DRAWING COMPARISON

HALL OF WORSHIP, OSOGBO —
AS-BUILT TO PROPOSED: SCOPE OF WORK

REPORT REFERENCE	DATE	CLASSIFICATION
RPT-2026-OSG-002	07 July 2026	Scope of Work Summary
PREPARED BY	REVIEWED BY	DRAWINGS REFERENCED
Vollmann Akarakiri	Jenyo Akarakiri	Hall of Worship As-Built Drawing; Hall of Worship Proposed Drawing

Figure 2. Proposed Drawing — reconstructed altar, relocated openings, extended Ante-Room and Flower Room, new columns, and new Fore Hall / Main Hall partition.

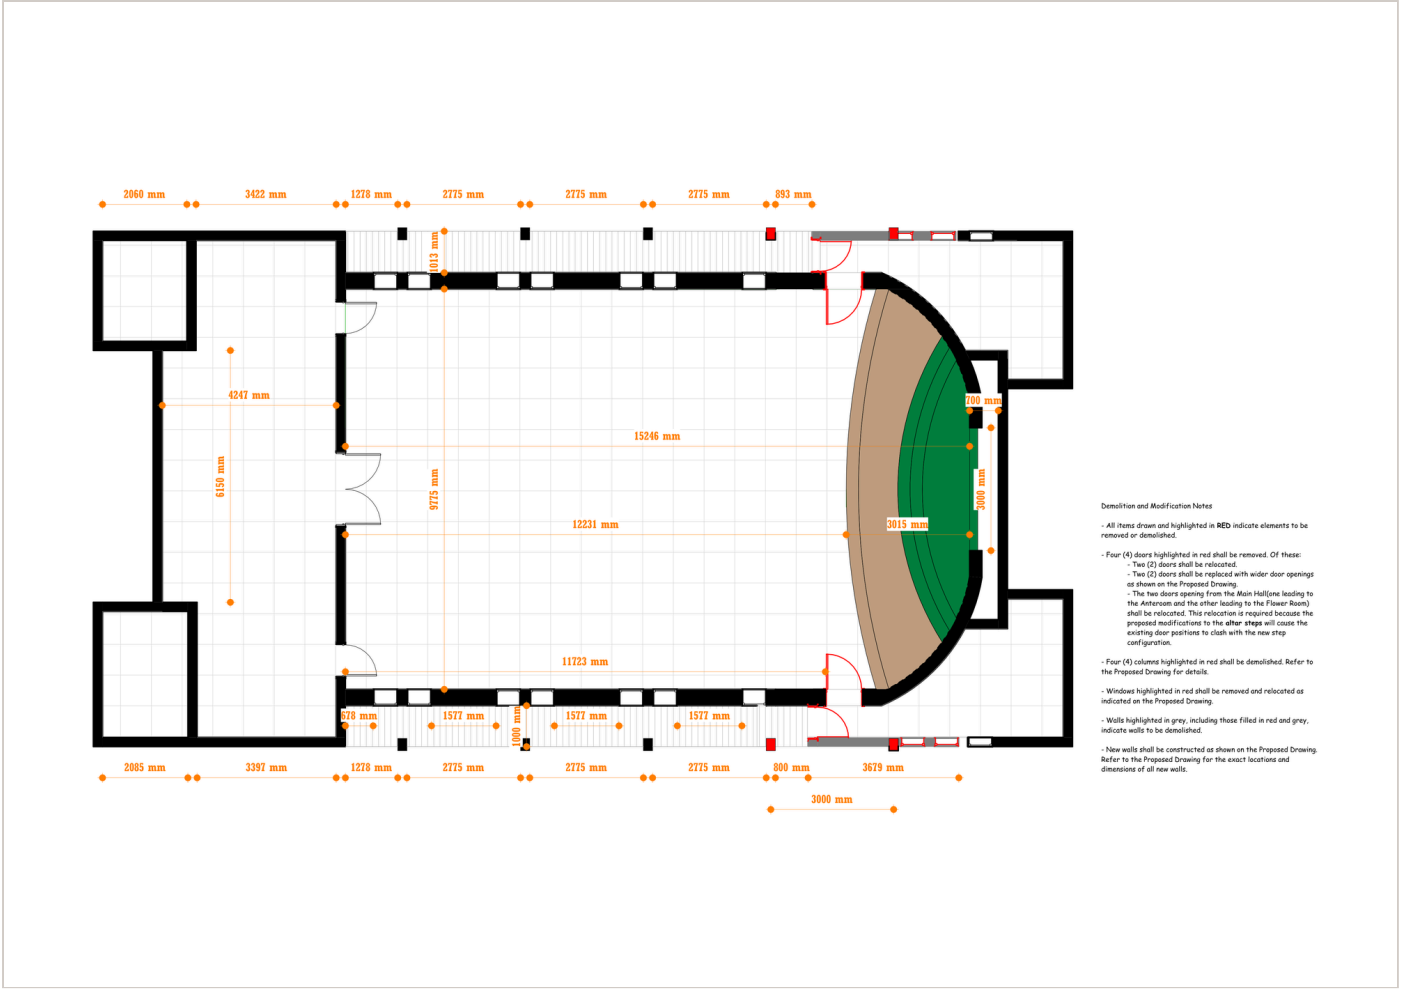
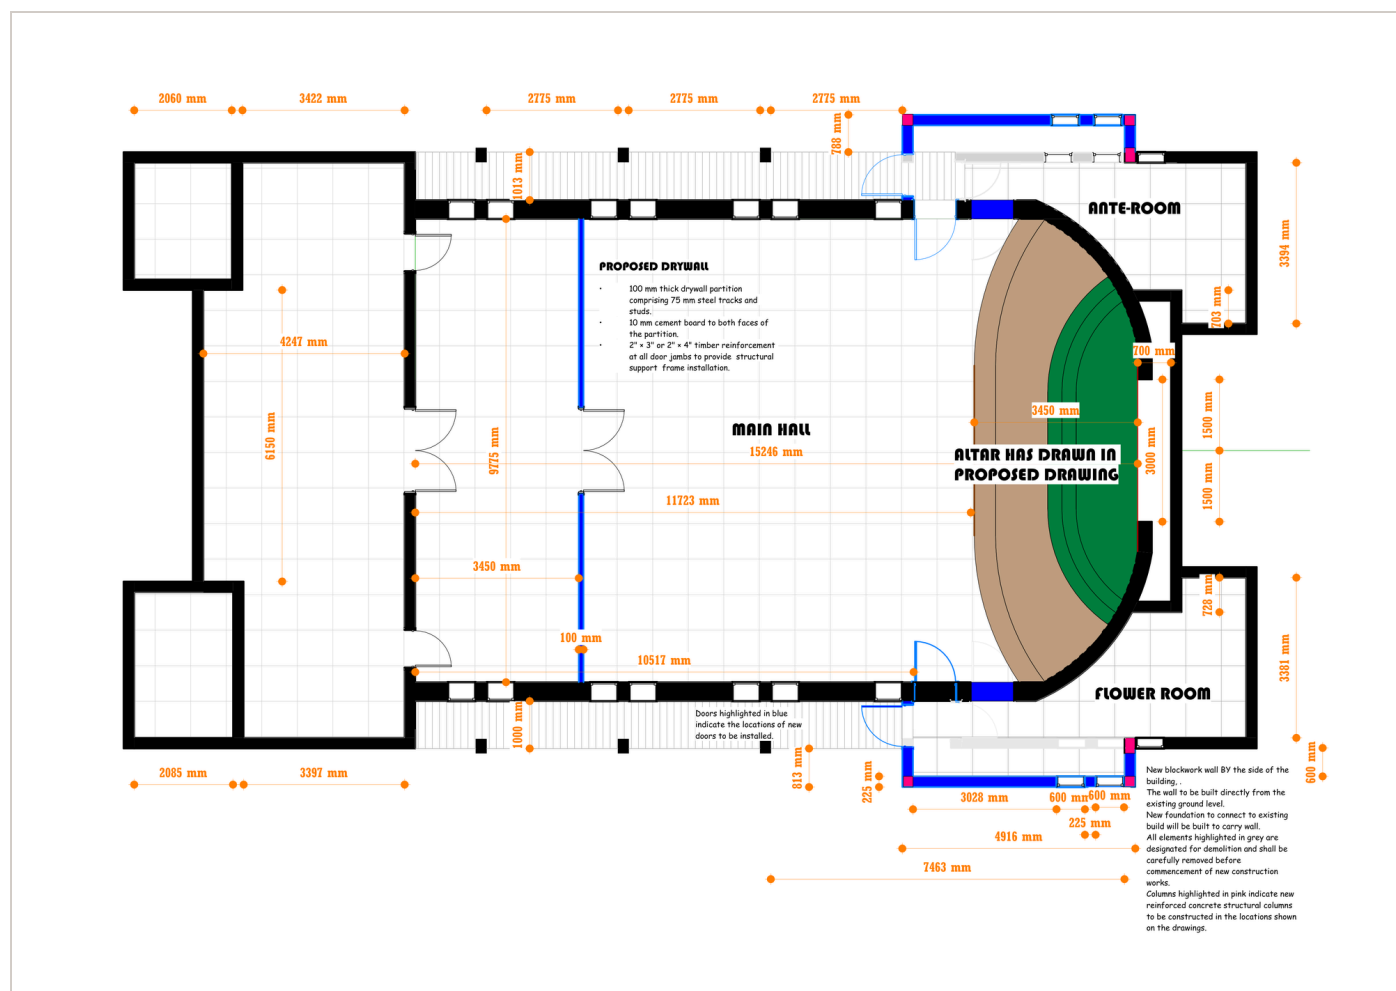
Reading the drawings: red marks the As-Built items to be removed; grey fill marks walls to be demolished; blue marks new walls and doors on the Proposed Drawing; pink marks new reinforced concrete columns. The building envelope along the Lobby–Main Hall axis (15.246 m) is unchanged — every change is contained within three zones: the altar apse, the Ante-Room / Flower Room corners, and the Fore Hall / Main Hall boundary.

Figure 3. Existing altar apse — chord 3000–3015 mm.

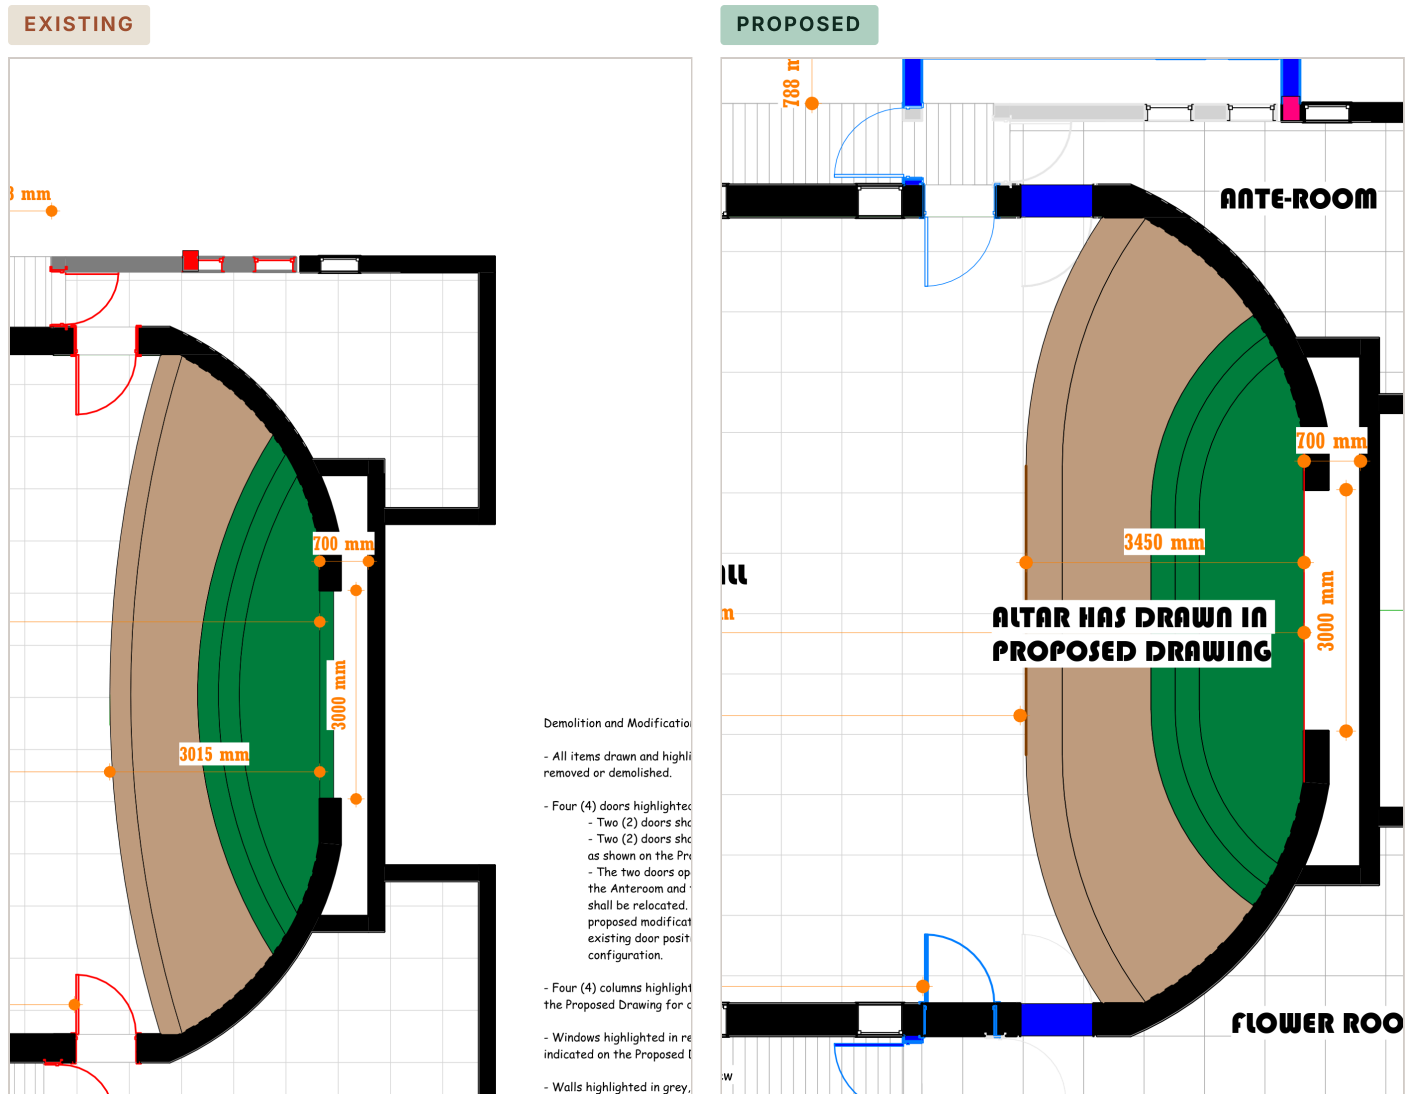
The altar chord widens from approximately 3.00–3.015 m to 3.45 m, an increase of roughly 450 mm. The radial depth to the Ante-Room-side corridor (3000 mm) is unchanged. The curve shown is diagrammatic; exact setting-out is a working-drawing item.

- Demolish the existing altar platform and steps in full.
- Reconstruct the altar wall and steps to the widened 3.45 m chord.
- Confirm final radius, centre point and step dimensions before construction.

Figure 7. Ante-Room extended approx. 703 mm beyond the existing line; new column (pink) and window.

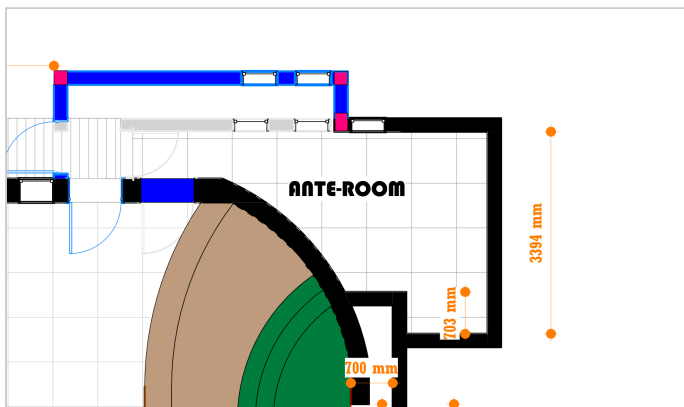
Both rooms are minimal, undimensioned corner spaces on the As-Built drawing. The Proposed Drawing extends each outward — Ante-Room to a depth of 3394 mm, Flower Room to 3381 mm — on a new wall built from ground level and tied into a new foundation, per the drawing's own construction note.

- Demolish the existing corner-enclosing walls at both rooms (grey fill on As-Built drawing).
- Excavate and cast new foundations, tied into the existing building.
- Build new blockwork walls, doors and windows to the extended lines shown.
- Cast new corner columns and tie the roof into the extended footprint.

Figure 9. New partition location — 3450 mm from the west wall / 10517 mm from the Lobby wall, with the drawing's own drywall specification note.

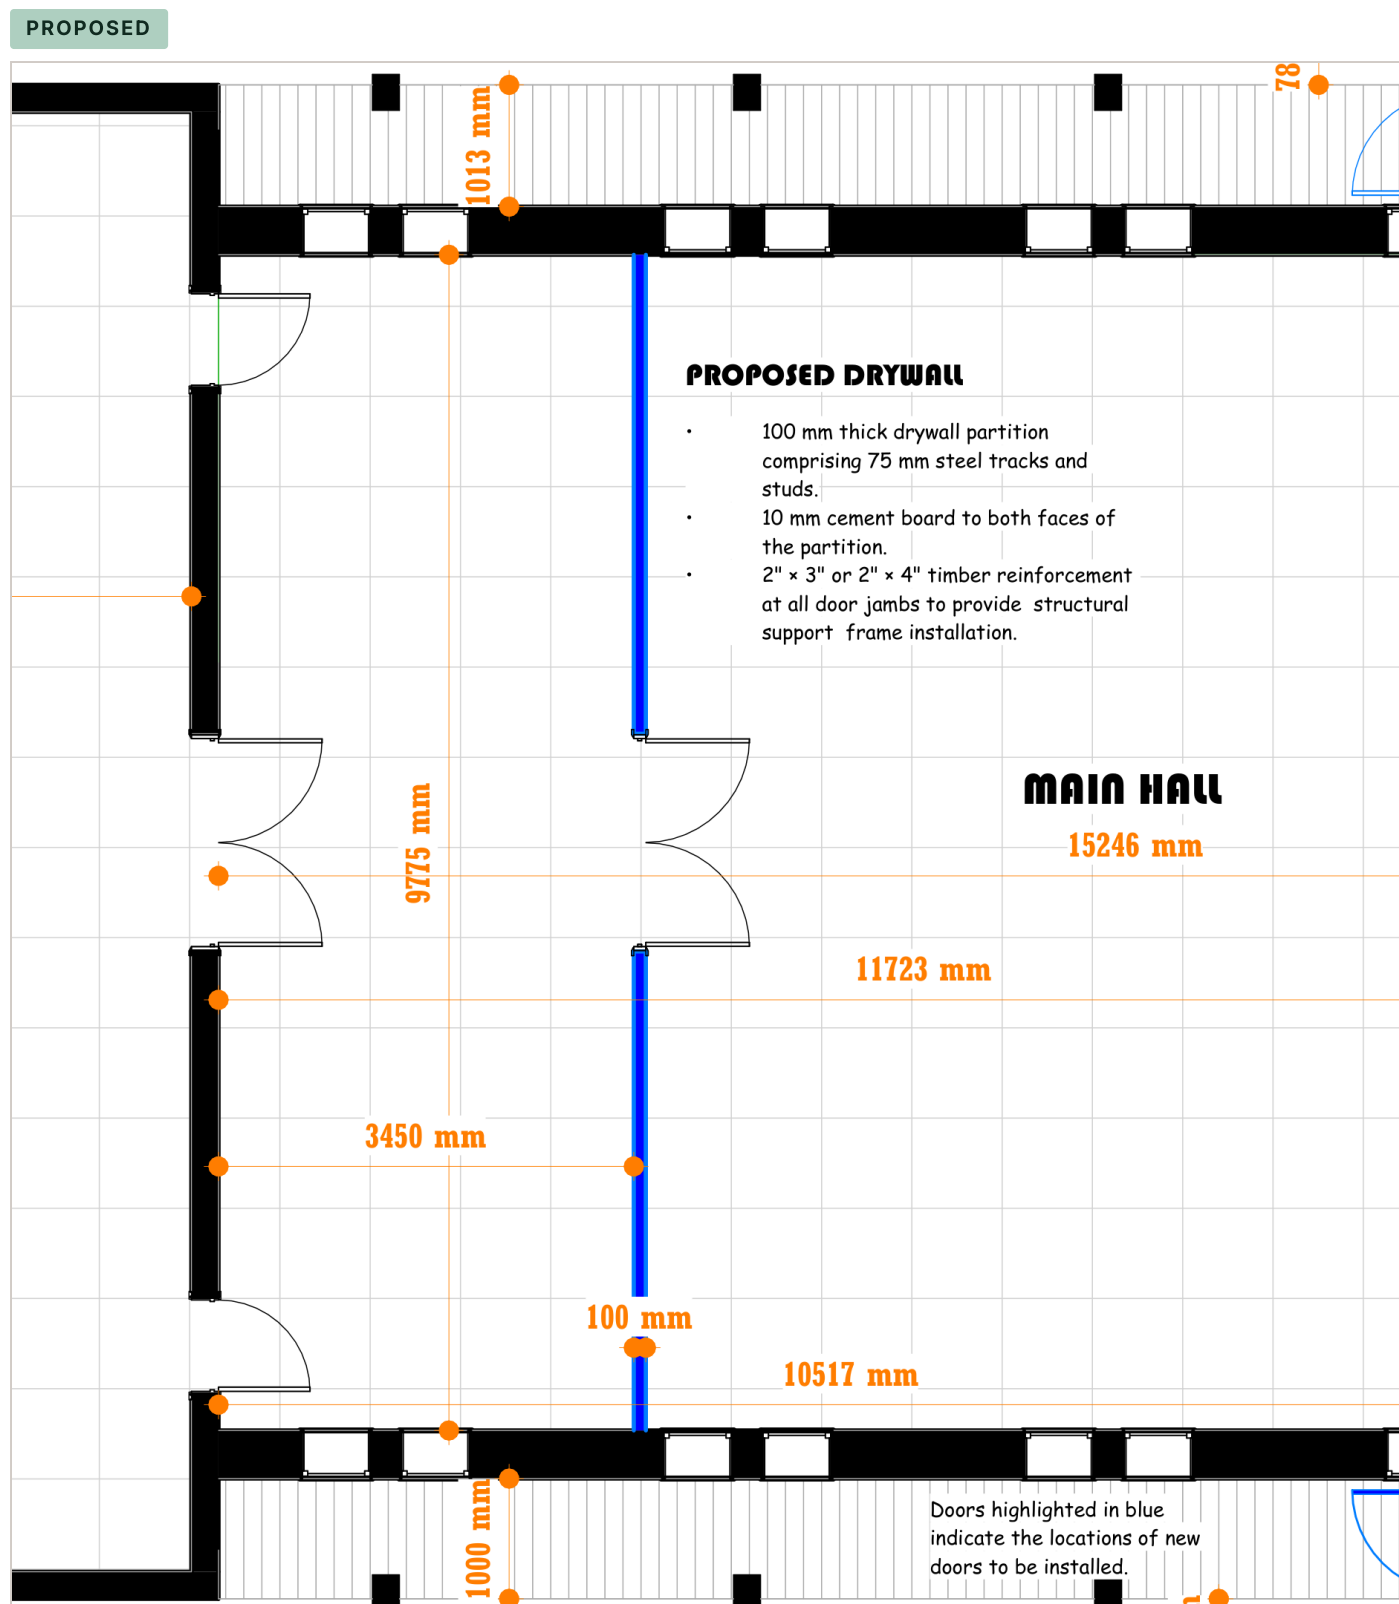
No partition exists on site today; the Fore Hall and Main Hall currently read as one undivided volume. The Proposed Drawing calls for a new partition, per its own note: 100 mm thick, 75

mm steel track and stud, 10 mm cement board both faces, with 2"×3" or 2"×4" timber reinforcement at door jambs.

- WORK TO BE DONE**
- Set out and build the new drywall partition per the drawing's specification.
 - Form one new door opening within the partition.
